Ref.: CVLNCCP02-G1-01

CVL Network – Network Code Condition G1 Network Change Proposal: Cardiff Bay Station platform changes and Overhead Line Electrification System (“OLE”) Commissioning Heath Junction to Caerphilly Bay Platform and Coryton

Appendix A – Proposed scheme for the energisation of the Overhead Line Electrification System (“OLE”) from Heath to Coryton and from Heath to Caerphilly

TRAN01-PSP-ZZ-CVL-DDR-Y-EP-000127-S1-P02 Caerphilly

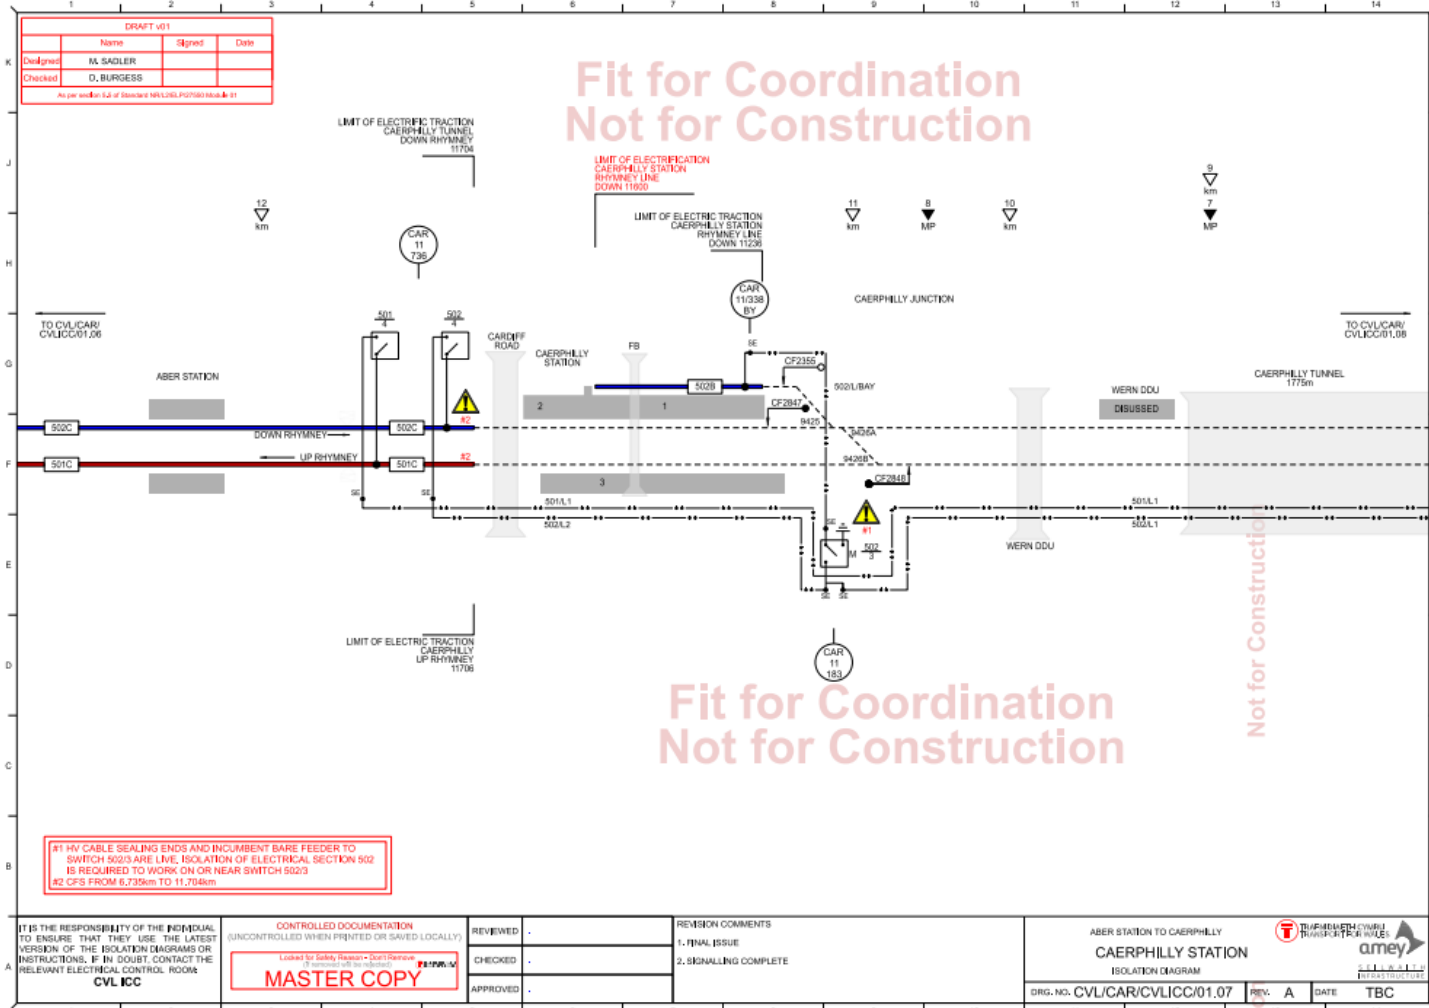
This energisation event will bring into use all 25kV OLE and HV distribution assets from the limit of electrification between Queen Street North and Heath Junction through to the end of the branch at Coryton and to the limit of electrification south of Lisvane and Thornhill Station.

The bay platform at Caerphilly Station will also have 25kV equipment brought into use via HV cabling from the limit of electrification south of Lisvane and Thornhill Station.

The part of the electrification system brought into use at this stage contains Permanently Earthed Sections (“PES”) at Birchgrove Station & Caerphilly Road Bridge. Trains will require a compatible on-board energy system to pass through these PES areas.

TRAN01-PSP-ZZ-CVL-DDR-Y-EP-000129-S1-P02 Queen Street North MPTSS to Heath Junction

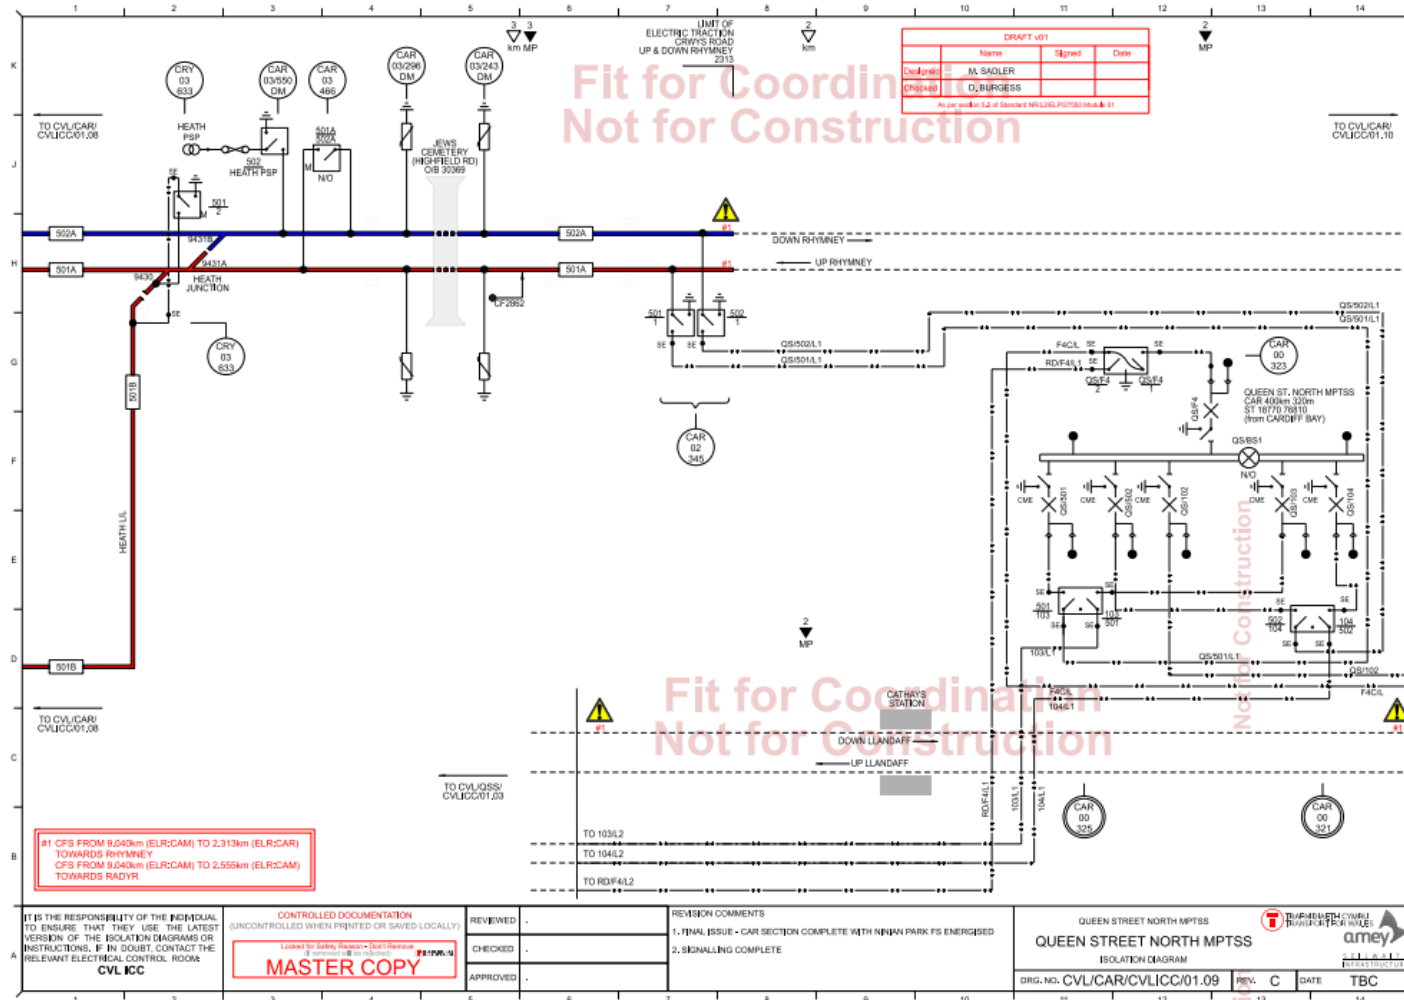
This will include the commissioning of a new substation at Queen Street North Junction.

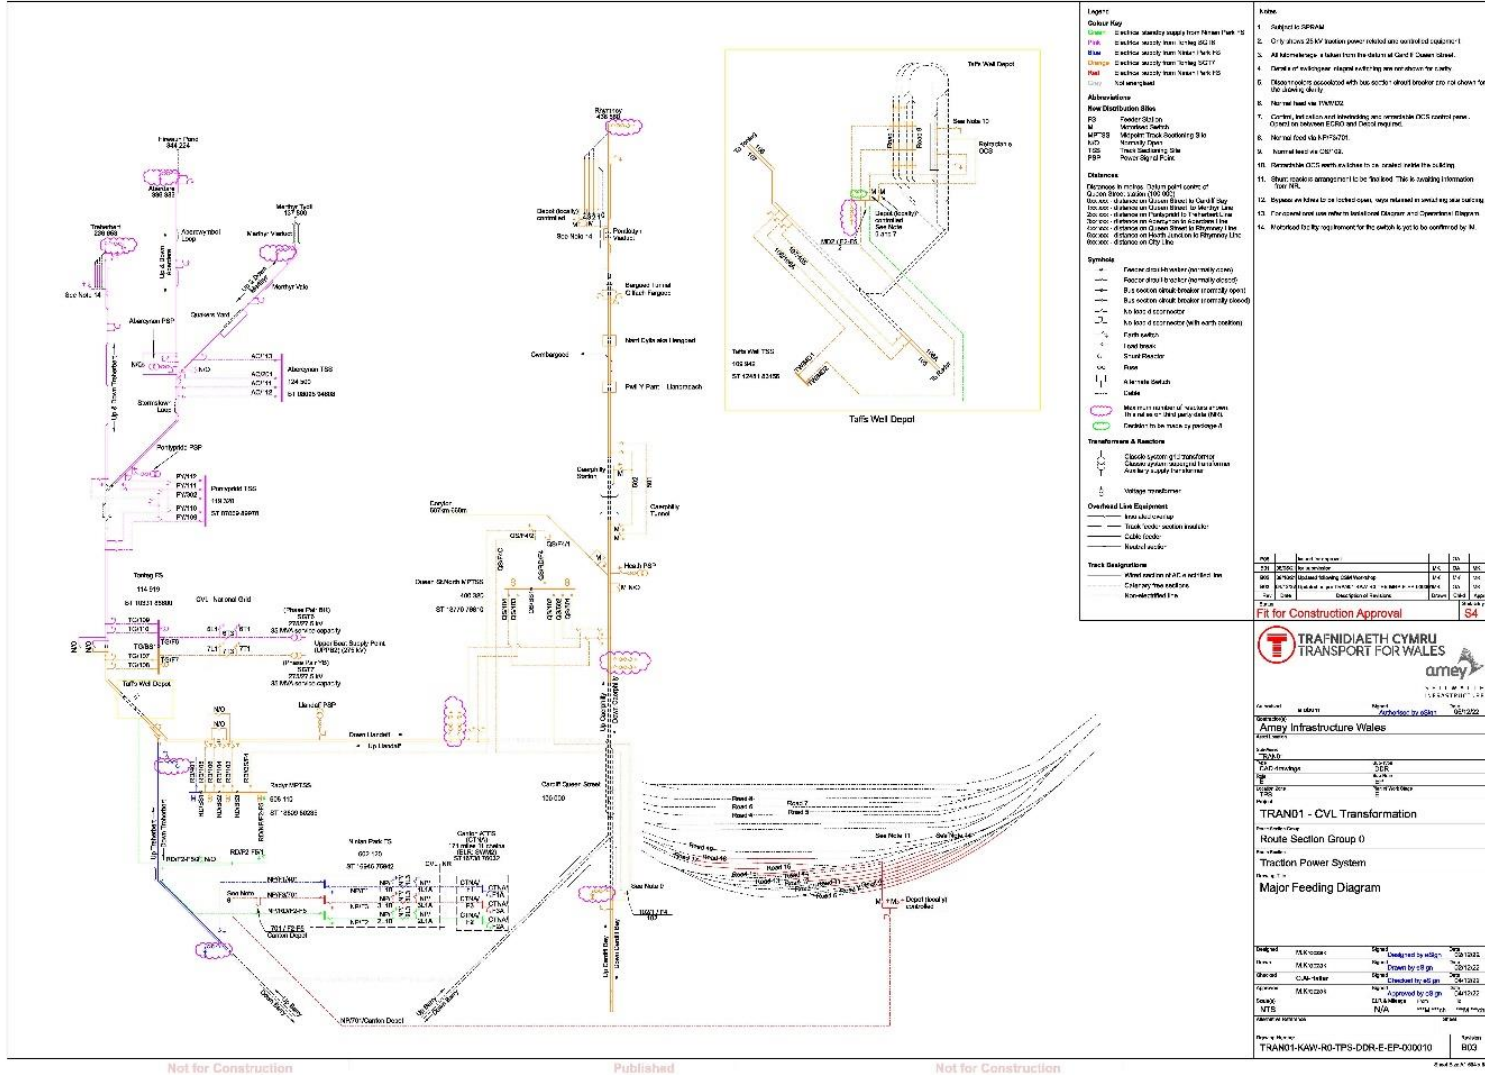
The island platform (existing platform 1 widened) will be constructed and entered into service at Cardiff Bay as platform 2. The existing platform 1 will be temporarily closed off to the public to continue ongoing CVL improvements.

To facilitate the new train path into platform 2 the existing track will be slewed from platform 1 Cardiff Bay, into platform 2 Cardiff Bay. The new down line will be installed as per the permanent design from the buffer and will tie into the existing alignment about 300m to the north of the station.

- CF2872 AWS to move with the track slew in the same position.
- Axle counters to move with the track slew in the same position.
- The existing buffer stop TPWS OSS to move and be renamed to CB02 BS(OSS) into Platform 2. (Indication at the WROC will remain the same).
Temporary Buffer Stop (CB2 BS) with reflective strips to be added.
